**Petition for Post-Certification Modification
Tanager Battery Energy Storage System Project**

Data Response Set 5

**Los Esteros Critical Energy Facility
03-AFC-02C**

LOS ESTEROS CRITICAL ENERGY FACILITY (03-AFC-02C)
Petition for Modification- Tanager BESS Project
DATA RESPONSE SET 5

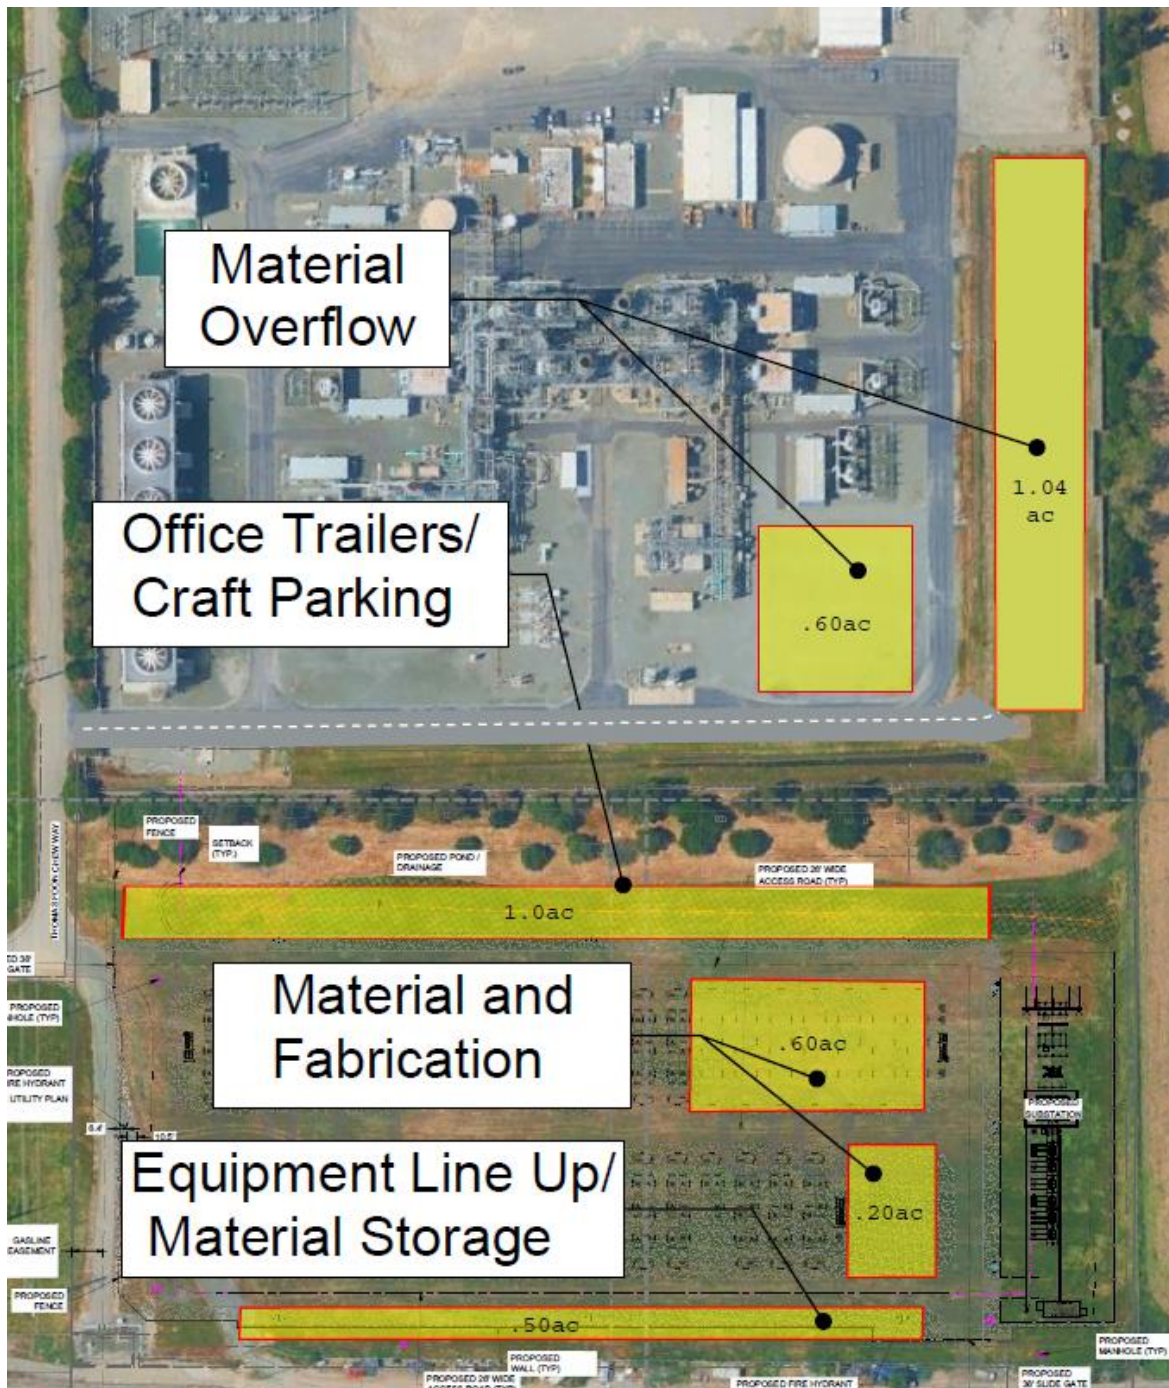
A111. *Provide further information clarifying what part of the project site and adjacent areas would be used for temporary construction parking and laydown. Include information on what "paved roads" or other roads would be used for these purposes. Please add these areas to the revised plan view or new map requested for Land Use in Data Request Set 4.*

RESPONSE: The Project will utilize available space at the Los Esteros Critical Energy Facility and available space within the Tanager site itself for laydown and parking, with the currently expected laydown areas highlighted below.

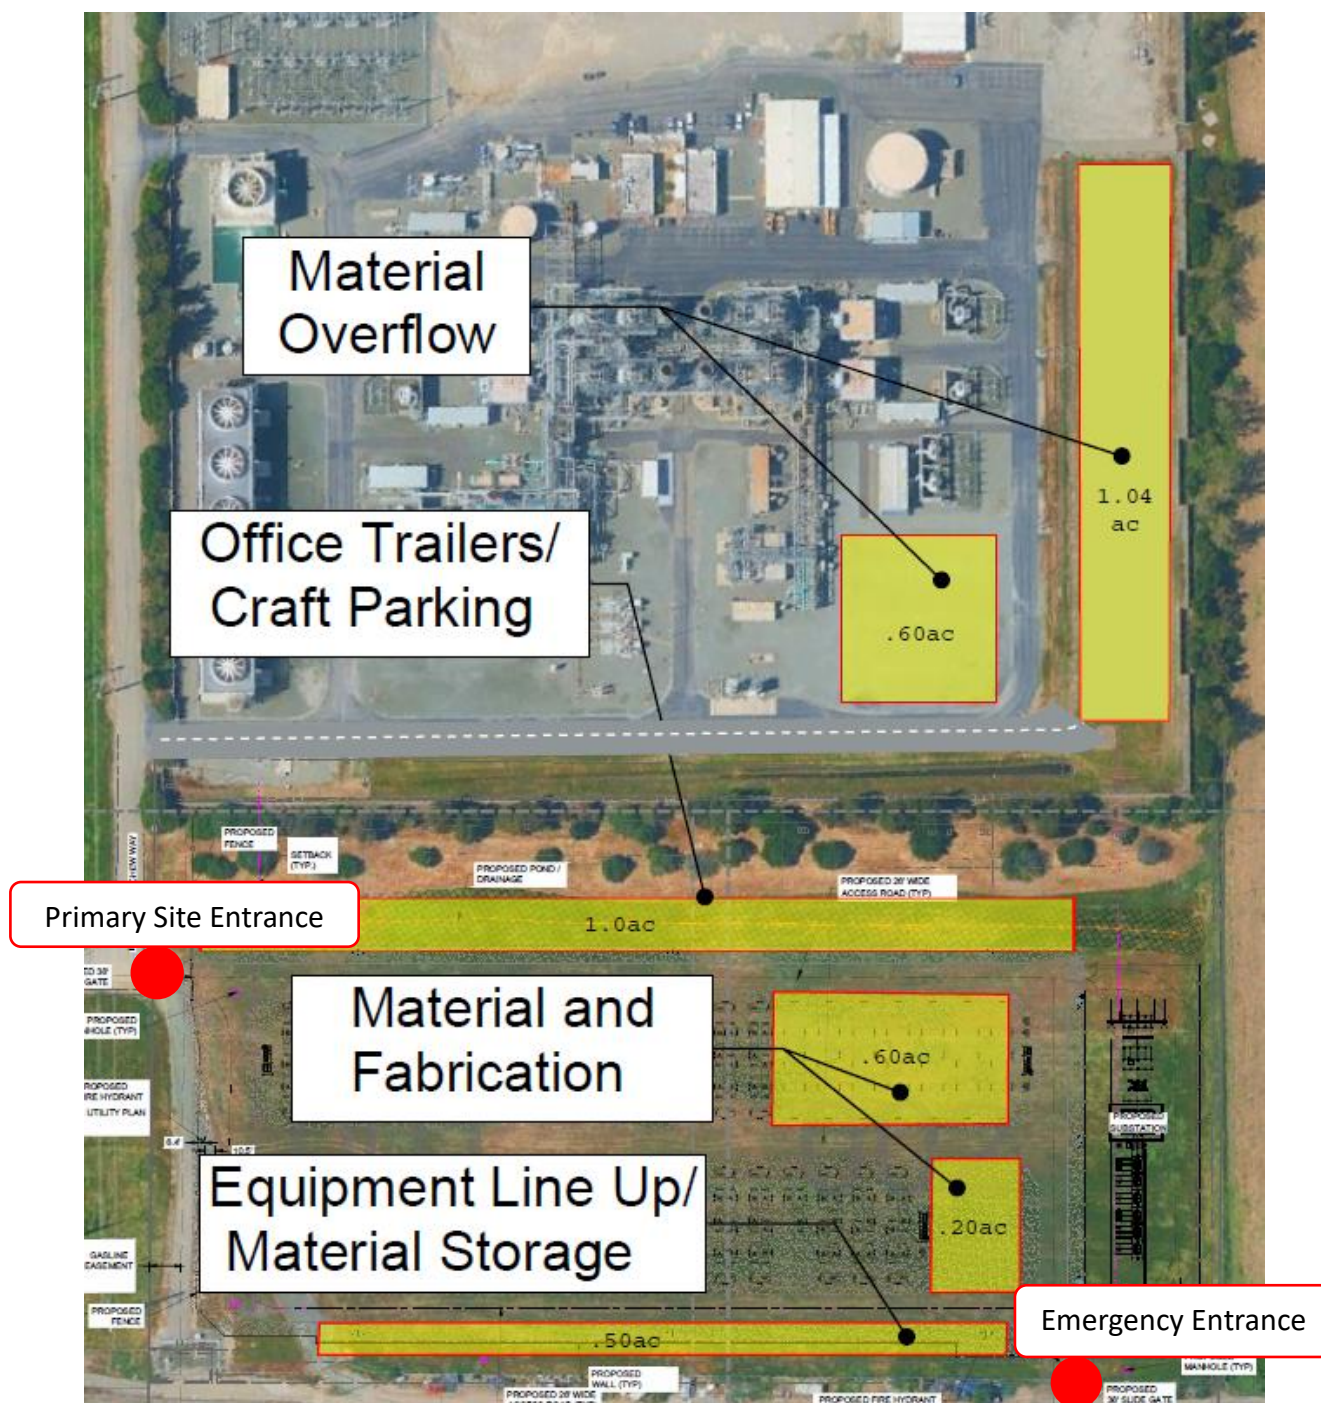
A112. *Please correct the conflicting statement that there would be no additional site access.*

RESPONSE: The current design includes two Project access points, utilizing Thomas Foon Chew Way to access the primary site entrance and Alviso Milpitas Road to access an emergency site entrance. Site entries are illustrated below with red

circles. Locations of site access points will also be included in final Project design.
